Re: MP 10\_0150 & MP 10\_0149 – Graythwaite Concept Plan

## Re- Revised EA Shore/Graythwaite

# **SHORE/GRAYTHWAITE REVISED APPLICATION.**

# SHORE/GRAYTHWAITE REVISED APPLICATION .

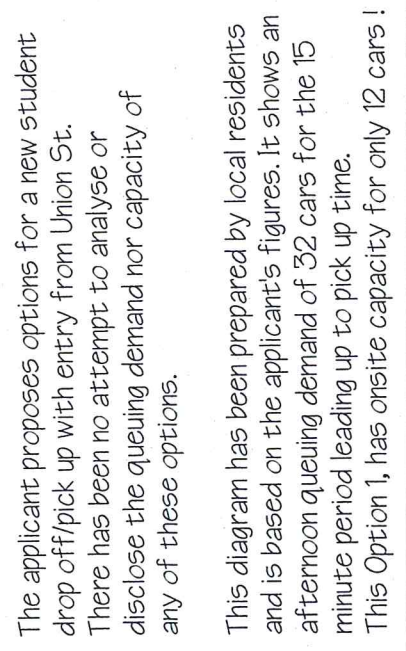
If Option 1 pick up was implemented with the onsite bus facility option figure 3, our daughter and many other school children who live in the area would have to cross,

- **5 double Shore driveways, measuring approx. 30 metres within a stretch of Union St of approx. 50 metres**
- 
- navigate between, exiting queued cars of Shore parents
- Shore teachers coming and going,
- mini buses and delivery vehicles,
- traffic entering and exiting Graythwaite and
- 8-12 full size coaches arriving and departing to take Shore students to Northbridge sports training
-

**all this while walking home from public bus, train and ferry services. I think this situation results in serious safety concerns !**

POTENTIAL TRAFFIC  
PLANNING OPTIONS USING  
EXISTING SHORE LAND

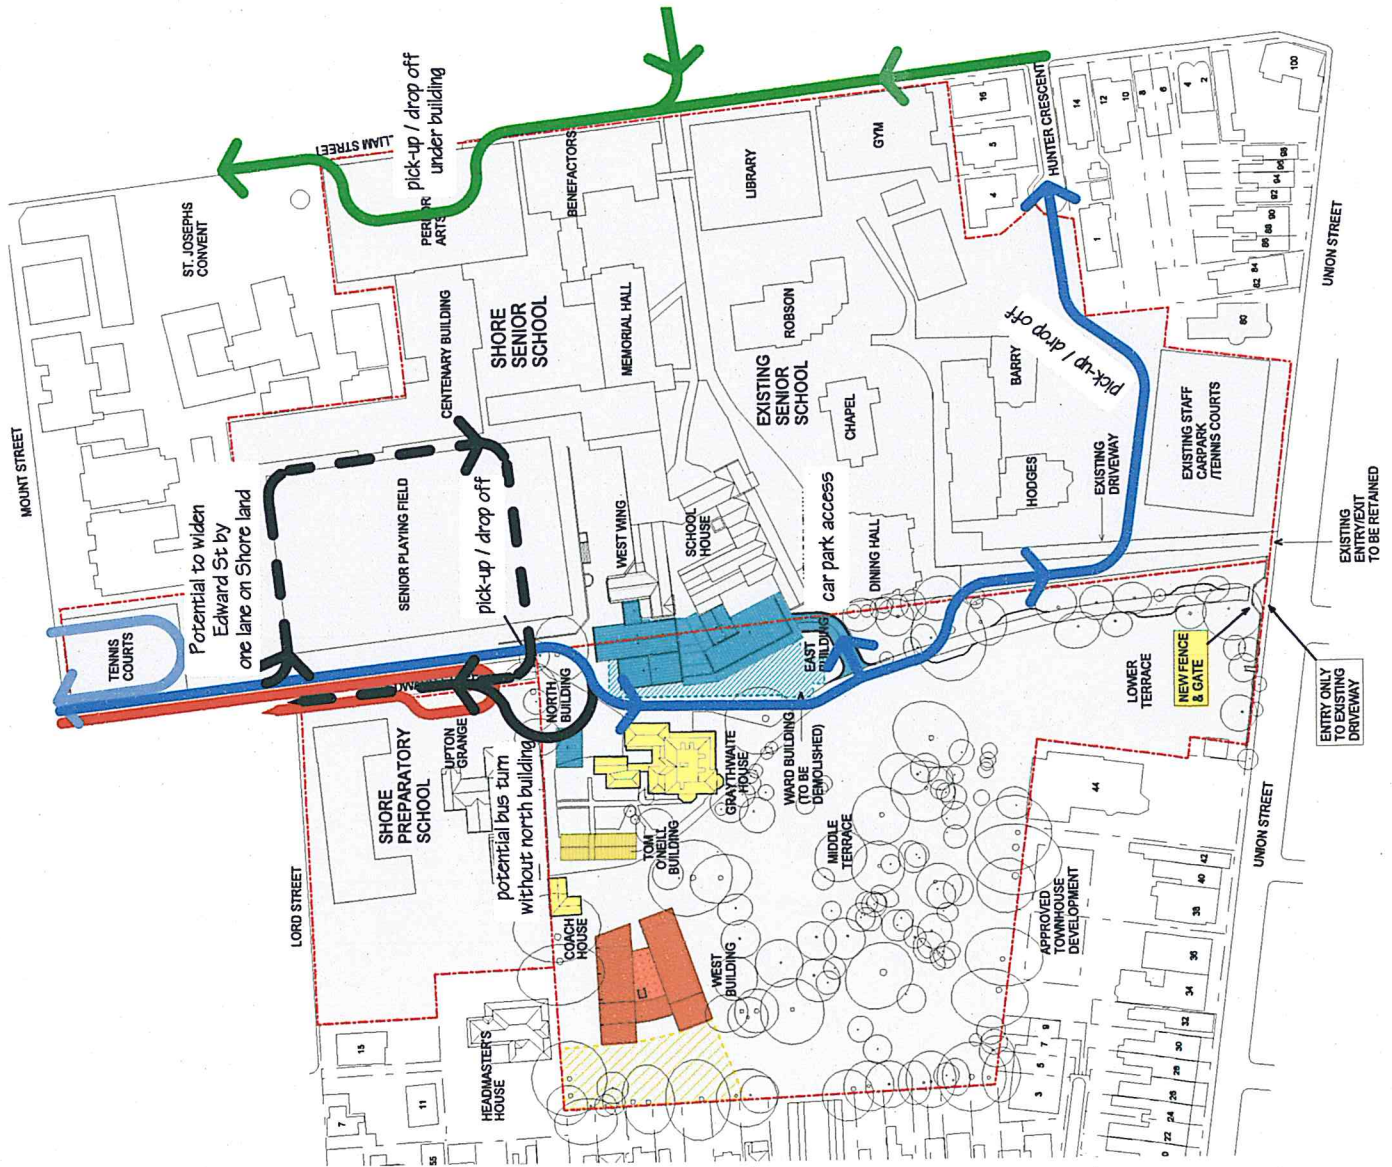
**If the preferred way to approach the traffic issues is to provide another pick up/drop off facility, the best option, that I'm not sure why is not in this report, I can take no claim to fame for suggesting but give all credit to the school. See attached diagram.**

**To add more credit to this stroke of brilliance and suggested pick up option, the facilities are already in place. No trees will have to be cut down, no parking spots taken off the street, no safety issues for pedestrians and NO RELOCATION OF A SEWER MANHOLE !**

Potential additional pick up using existing playing field perimeters, as currently used by Shore on special occasions

Project  
GRAYTHWAITE - CONCEPT APPLICATION  
SYDNEY CHURCH OF ENGLAND  
GRAMMAR SCHOOL (SHORE)  
Drawing Title  
VIEW FROM REAR 31 BANK ST  
(SHEET 1 OF 2)  
Drawing No.  
A-502-A  
Revision  
G

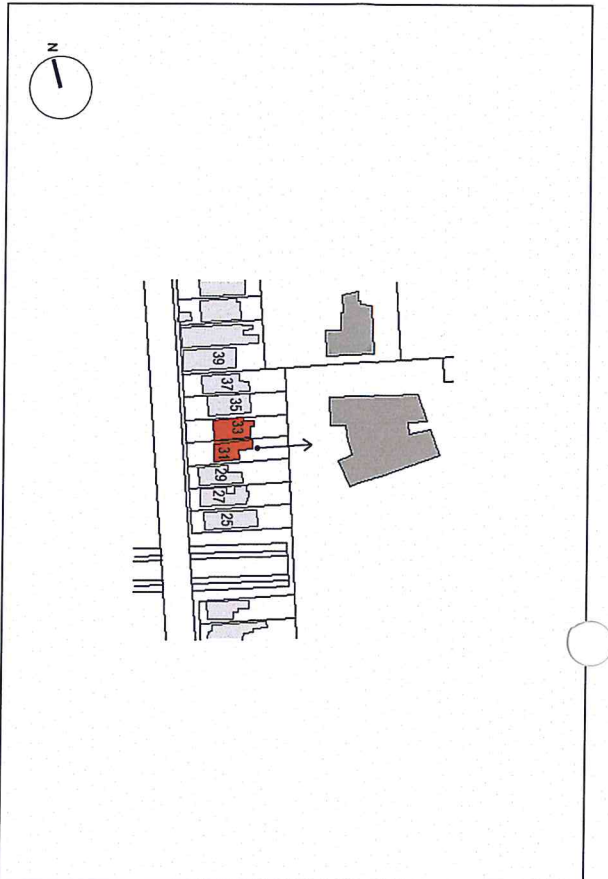
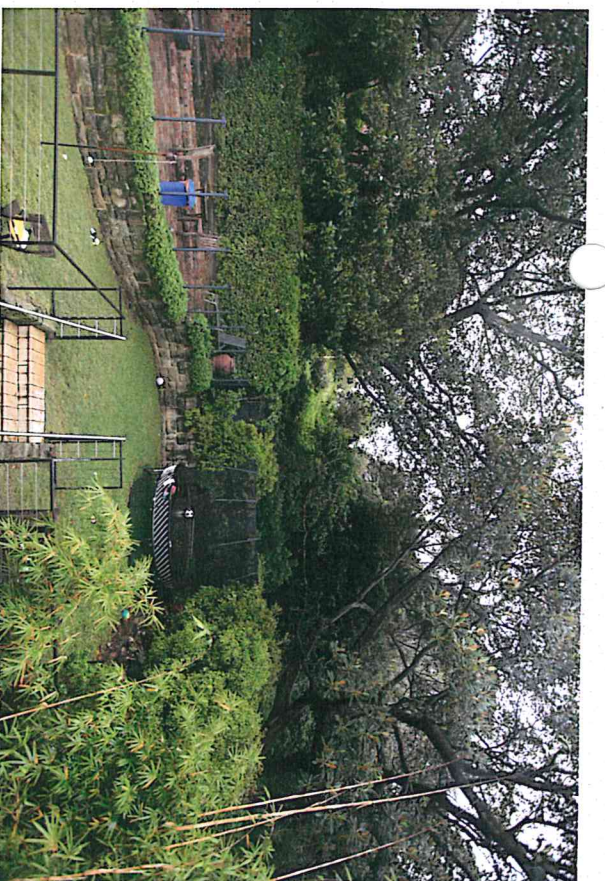
After that meeting the design was changed so I think that the photo montages reflect design no. 2 rather than design no.3 and the site poles definitely must have related to design 2 not the design that is in this application (let’s call it design 3).

In A.502A Photo C there is a green box structure on the right hand side of the proposed building and it is not there in photo B. The same applies in A.502-B and A.503. I question the professionalism and accuracy of these photo montages and ask what is the appearing and disappearing green box?

The proposed planting that has been added to the photo montages , are these plants represented at their potential maximum size or size when planted?

Please note that even if the first elevation of the building on the western façade is 8.5 metres , the further elevations can be clearly seen even with screen planting. The height limit of 8.5 metres must be adhered to and these plans need to be refused.
